Interim Status Change Number 1: Interim Status Groundwater Monitoring Plan for the LLBG WMA-1

**RCRA INTERIM STATUS GROUNDWATER MONITORING PLAN
 INTERIM CHANGE FORM**

Change Number: <i>(Obtain Change Number From Interim Change Custodian)</i> RCRA-CN-01_DOE_RL-2009-75_R1		Date: 04/30/2020
Document Number: DOE/RL-2009-75	Title: Interim Status Change Number 1: Interim Status Groundwater Monitoring Plan for the LLBG WMA-1	Rev: 1
Originator: Tessa Clark		Phone: 3605203189

Figure 1-2. 218-E-10 Burial Ground at LLWMA-1

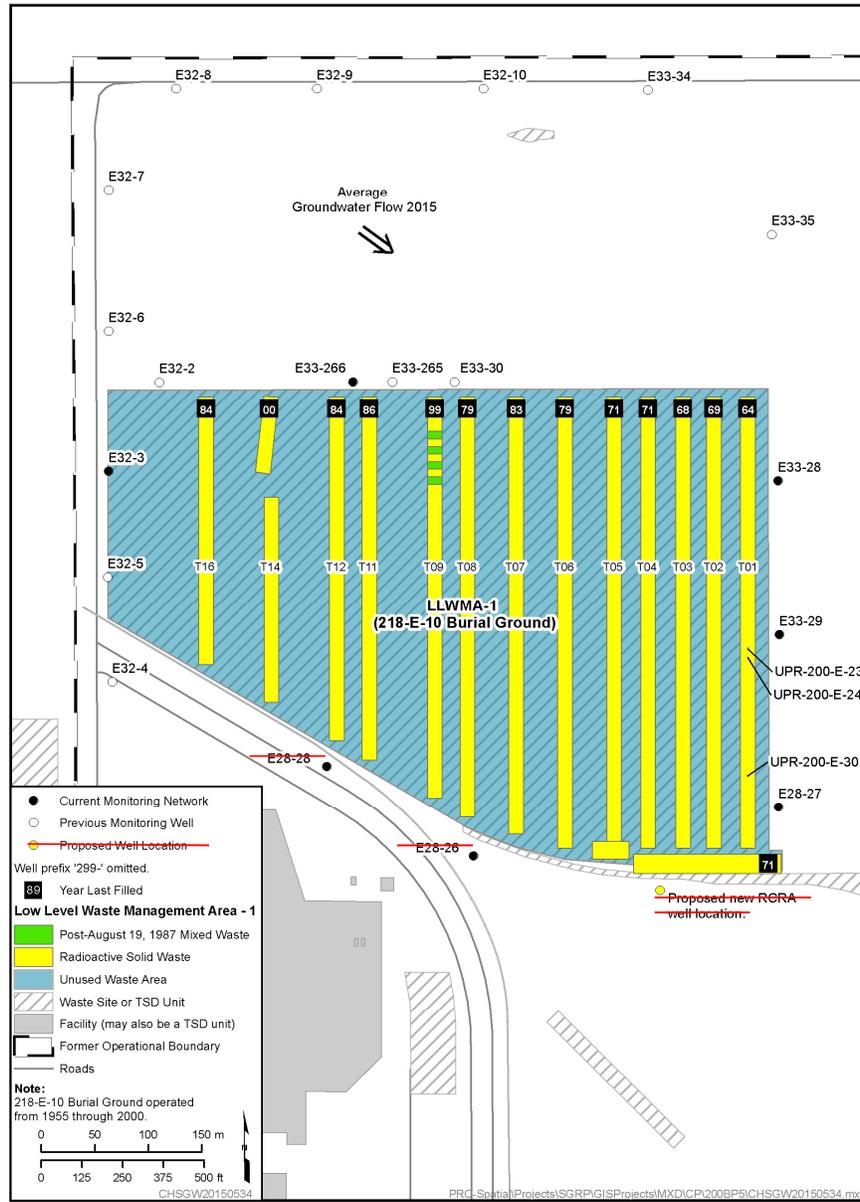
- Remove well 299-E28-26, well 299-E28-28, and proposed well from Figure 1-2 and Figure 3-1.
- In the Introduction on pg. 1-4: change number of downgradient wells from "six" to "three;" delete sentence "One of the six downgradient wells will be a new well installed to monitor the southeast corner of LLWMA and will be sampled quarterly for one year;" change number of existing groundwater wells from "seven" to "five;" and delete "and proposes a new well be added to the well network for the total of eight wells."

-Due to changes in groundwater flow direction from south-southeast to east-southeast, the previously-designated downgradient wells 299-E28-26 and 299-E28-28, and the proposed downgradient well, are no longer applicable to the monitoring network and are removed from this groundwater plan. The monitoring well network changes from eight total wells to five (two upgradient and three downgradient). All text, tables, and figures are revised to reflect this change in the groundwater flow direction and monitoring well network.

Figure C-1. Well 299-E28-26 Construction and Completion Summary

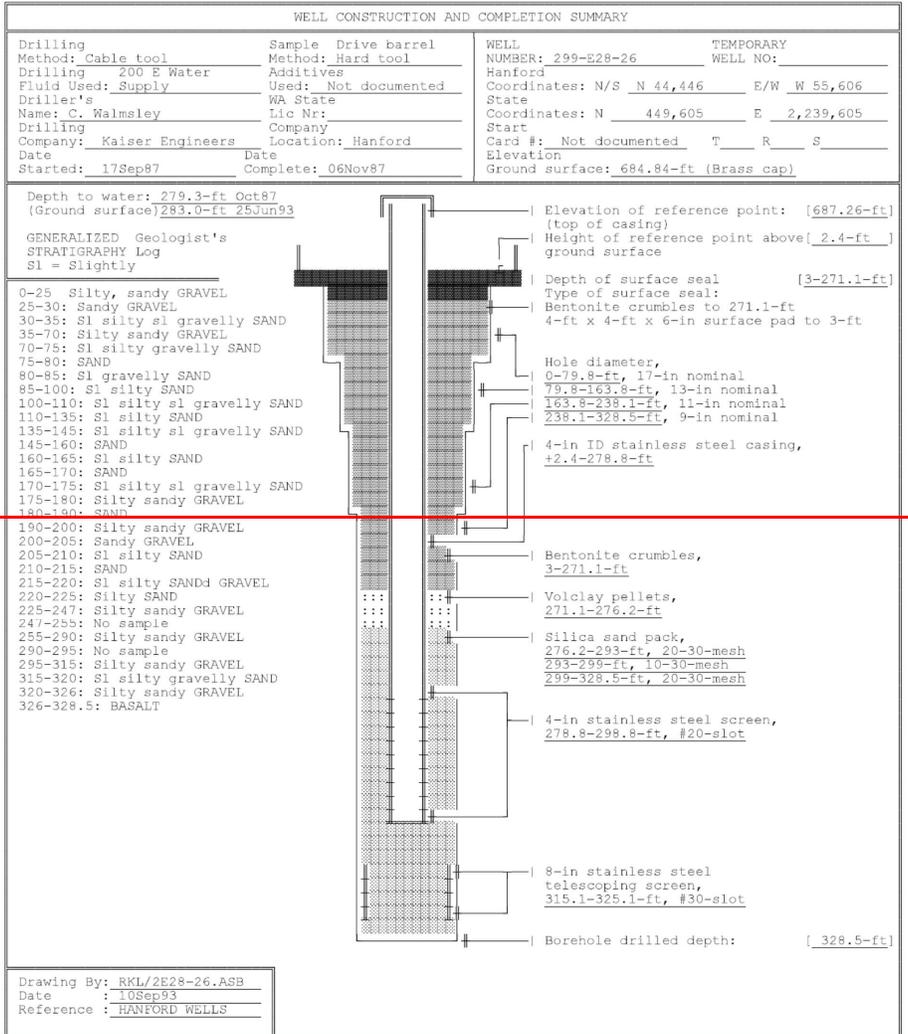
-Delete wells 299-E28-26 and 299-E28-28 from Table of Contents (Figures) and Table C-2, and delete Figures C-3 and C-4, in Appendix C.
